Engeren Resources plans to plug and abandon the Jicarilla 110 #3 per the attached procedure.

## Proposed P&A

Re: Permanent Abandonment  
Well: Jicarilla 110 #3

CONDITIONS OF APPROVAL

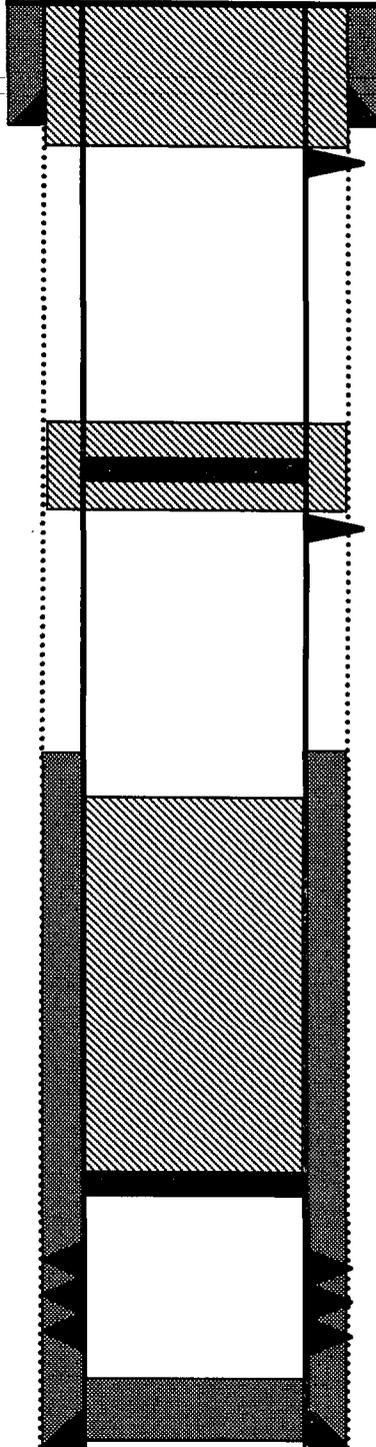
1. Plugging operations authorized are subject to the attached "General Requirements for Permanent Abandonment of Wells on Federal and Indian Leases."
2. Farmington Office is to be notified at least 24 hours before the plugging operations commence (505) 564-7750.
3. The following modifications to your plugging program are to be made:
  - a) Set plug #2 (1257-1157) ft. Inside/outside to cover the Nacimiento formation top.

Operator must run a CBL from 3068 ft., or as deep as possible, to verify cement top. Outside plugs may be revised, based on CBL result. Submit electronic copy of the log for verification to the following BLM address: [tsalyers@blm.gov](mailto:tsalyers@blm.gov)

See COA

Plug #2: 1181' - 1081'  
Class B cement, 45 sxs:  
28 outside and 17 inside
